MODIFICATION SHEET NO. RDSO/2009/EL/MS/0378 (REV.0), DATED 29.05.2009

Modifications in NS/AS Controller Cards (PPA988B02) and Gate Unit of Power Converter of three phase locomotives.

Annexure-1

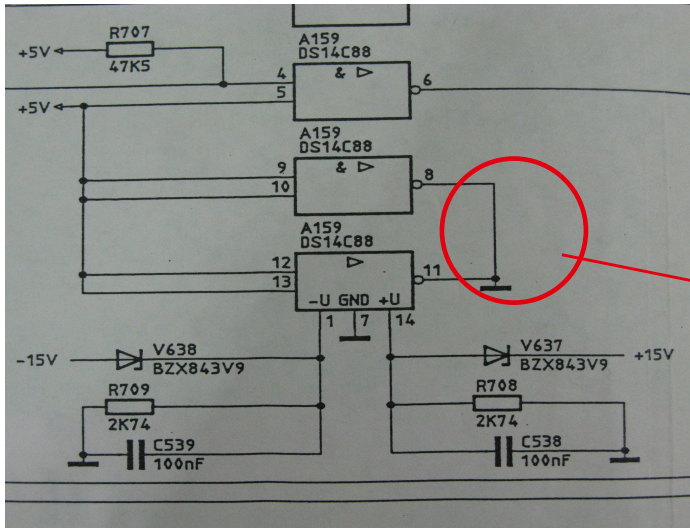
It has been observed that NS/AS controller card (PPA988B02) is contributing approximately 50% of the card failures of power converter of 3-phase locomotives in the recent years. This card is being imported by M/s. BHEL & M/s. NELCO and indigenised by M/s. BTIL since 2001. After make-wise failure analysis of these cards, it is seen that the failures (FRPCPY) in BTIL make cards is 23.2% as compared to 2.7% of BHEL. Based on failure investigation reports given by M/s. BTIL, it has been observed that majority of the failures are because of failures of IC14C88 and in some cases failures of these ICs are along with zener diodes V637 & V638. The matter was taken-up with M/s. BTIL and it was found that a modification in this IC was cut-in by the OEM in the year 1999, where Pin No. 8 & 11, which were connected to ground earlier, were disconnected from the ground. This was done to avoid failure of this IC and zener diodes. The details have been shown in **Annexure-1**.

3.1 Pin No. 8 & 11 of IC 14C88 in PPA988B02 card are connected to ground in BTIL make.

4.1 Pin No. 8 & 11 of IC 14C88 in PPA988B02 card are to be isolated to remove grounding of these pins in M/s. BTIL make cards.

Existing Gate Unit without Insulating Plate

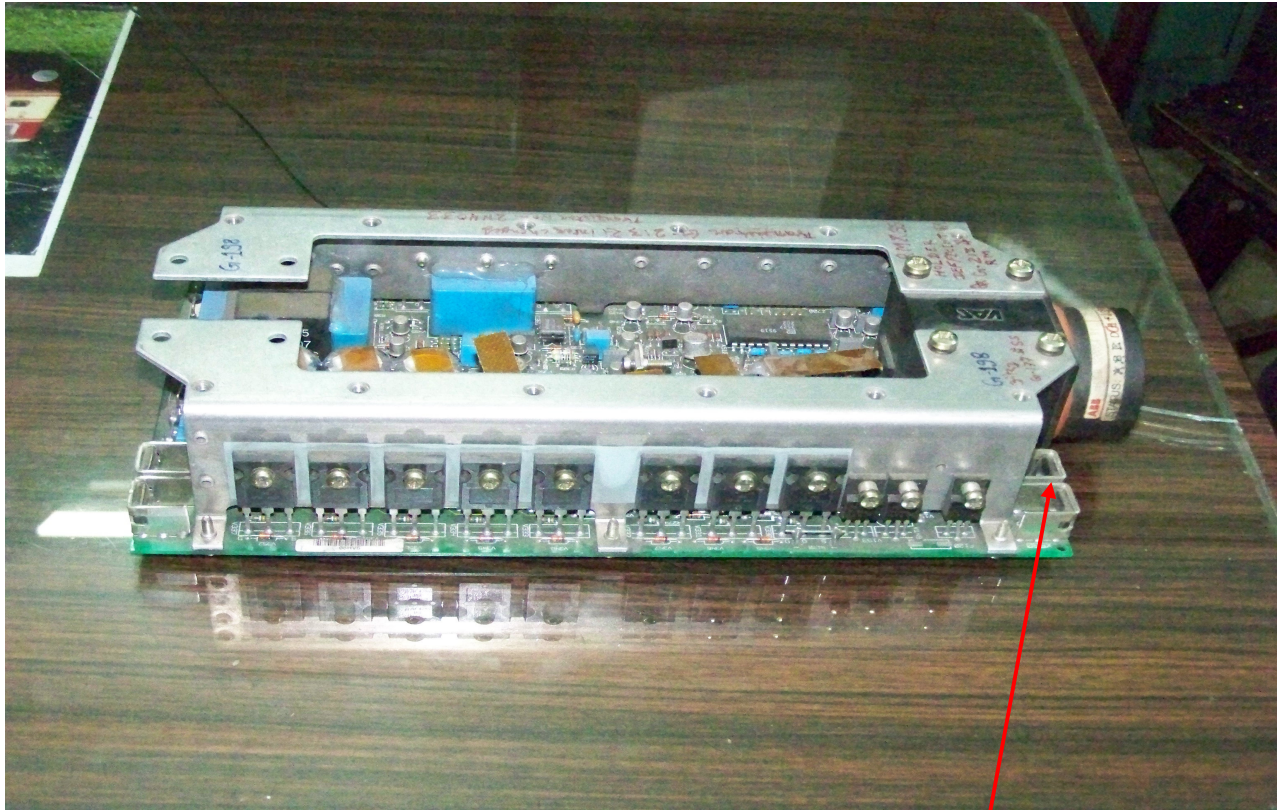
There are approximately 30% failures of Gate Unit which have been observed during last 06 years. M/s BTIL investigated and highlighted the cause of failure of Gate Unit (GVA578A01) due to less clearance between Gate and Cathode terminal. This results in failure of GU of Power converter. In order to avoid this failure it is proposed to insert an insulating sheet between Gate and Cathode plates of gate unit.

3.2 Photograph of Gate Unit given at **Annexure-2**

4.2 Insert insulating plate between gate and cathode of Gate Unit as shown in photograph at Annexure-3
